DELEGATED REPORT

PLANNING PERMIT APPLICATION

Application number:	TP-2022-161
Applicant:	Trennery Property Group Vic Pty Ltd C/- Contour Consultants Aust Pty Ltd
Address:	253-257 Domain Road, South Yarra, 3141
Proposal:	Use of the land as a restricted place of assembly (private members club) and residential hotel (including a live music venue), to sell and consume liquor (general licence), partial demolition, buildings and works, external alterations, and painting associated with the construction of a residential building, an associated reduction of the statutory car parking provisions, to provide some of the car parking provision on another site, and to alter access to a road in a Transport Zone 2
Date of application:	29 March 2022
Responsible officer:	Matthew Mukhtar, Acting Principal Planner

Figure 16 – indicative breakdown of patron numbers in select locations on the ground floor (Source: applicant)

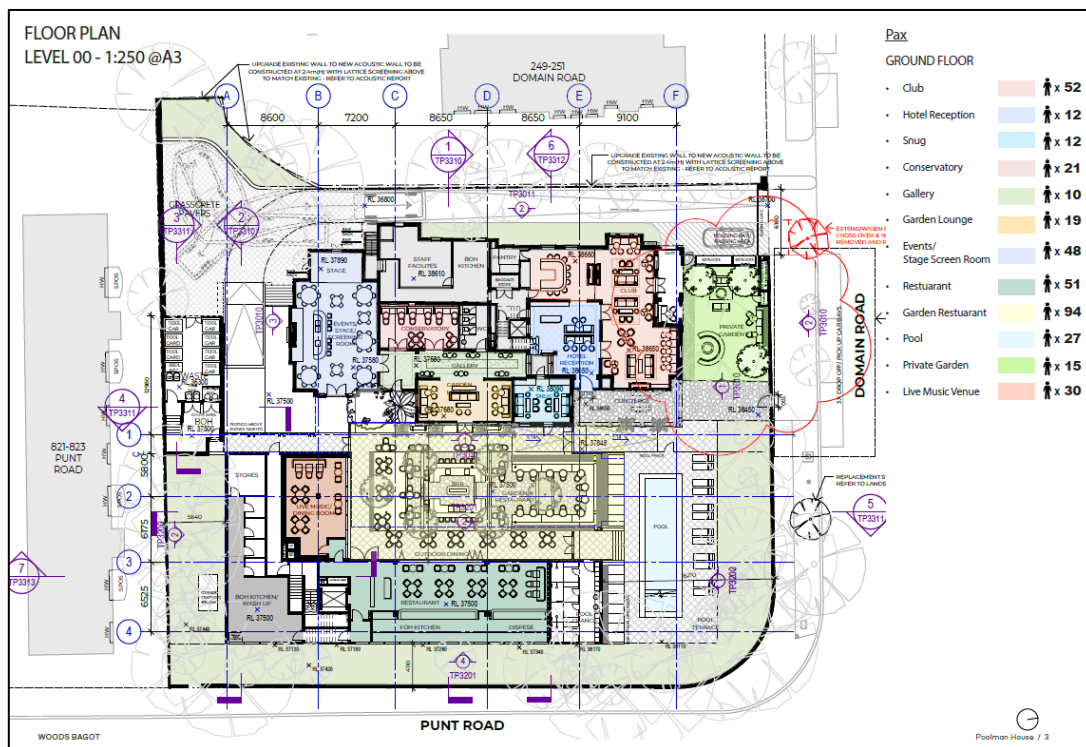
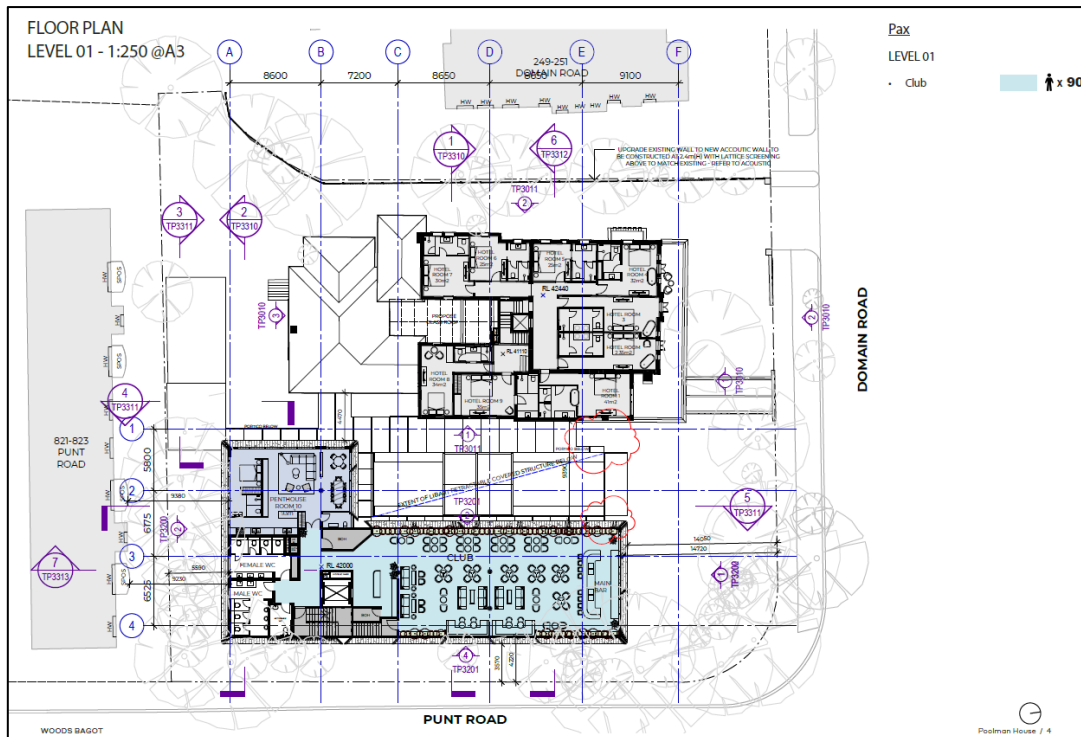
- it appears to be based on an indicative number of patrons (discussed earlier in this report) in each location of the venue;
- it appears to assume that there will be no patrons in external areas during the night period (10pm to 7am) which conflicts with the planning report which proposes that the external spaces will be open until 11pm (Sunday to Thursday) and 12am (Friday to Saturday);
- it does not appear to consider the noise generated by the proposed use on sleep disturbance and the ability (or otherwise) of residents being able to leave windows open at night, to enjoy outdoor living spaces etc;
- it is unclear whether the acoustic assessment was prepared in the context of the valet parking system.

Council officers are cautious that changes to assumptions may create a situation where the findings results in unacceptable outcomes or that require changes to the proposal. It is therefore considered inappropriate to address these matters through planning permit conditions. Such concerns may ordinarily be dealt with through the planning permit process. However, as this option is not available given the lodgement of a failure appeal, in the view of Council officers, the noise from the proposal is considered to be excessive and unacceptable.

Figure 33 – extract of the architectural plans (Section 1) with Clause 55.04-1 setback line added by Council

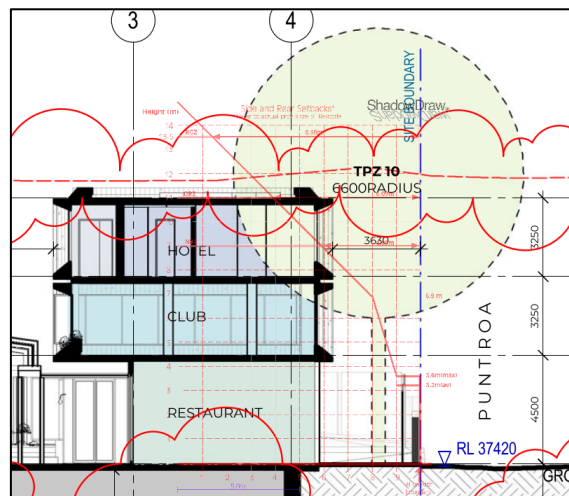
- in regard to the west, the existing heritage building is retained, as such Clause 55.04-1 is not applicable;
- in regard to the east, as depicted in Figure 33 below, there is a proposed non-compliance to the third storey of the addition;
- in regard to the south, as depicted in Figure 34 below, there is a proposed non-compliance to the third storey of the addition.

In the view of Council officers, the proposal does not result in unacceptable amenity impacts to 819-823 Punt Road by virtue of the combined building separation being over 9m and the proposed shadows found to meet the Objective of Standard B21 (discussed below). However, for the reasons expressed in Chapter 10.4 and 10.5 the proposal fails to achieve an appropriate neighbourhood character outcome.

Figure 35 – extract of the 20-minute walking map from the Transport Assessment

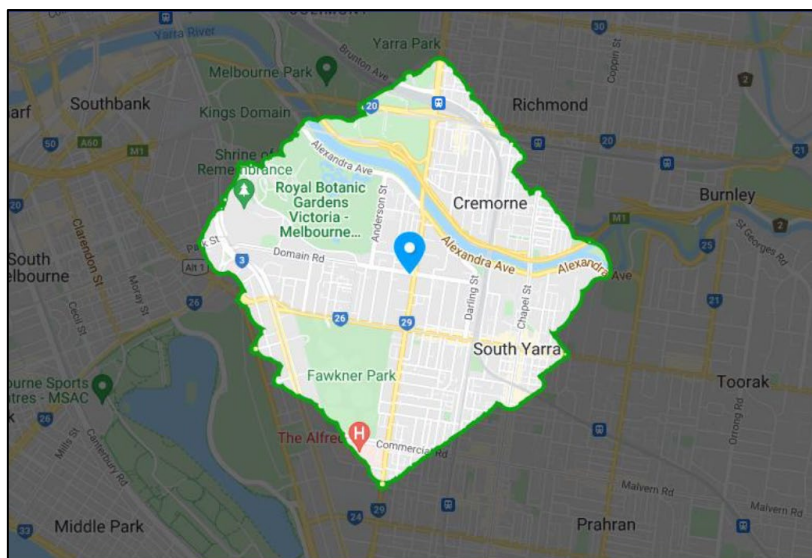
- the Transport Assessment anticipates that 44 and 103 patrons will arrive by walking and public transport respectively. The Transport Assessment includes a map of 20-minute walking distance – see **Figure 35** below. Removing public parks and gardens, Council officers do not consider the area to be a large catchment and therefore an extremely high membership uptake in a confined area in order to walk. Council officers also take the topography into consideration, thinking it ambitious to think someone would walk 1.3km along Punt Road from Richmond Station to the proposed venue.

Given the above, it is the view of Council officers that the anticipated car parking demand is not sufficiently explained or justified.
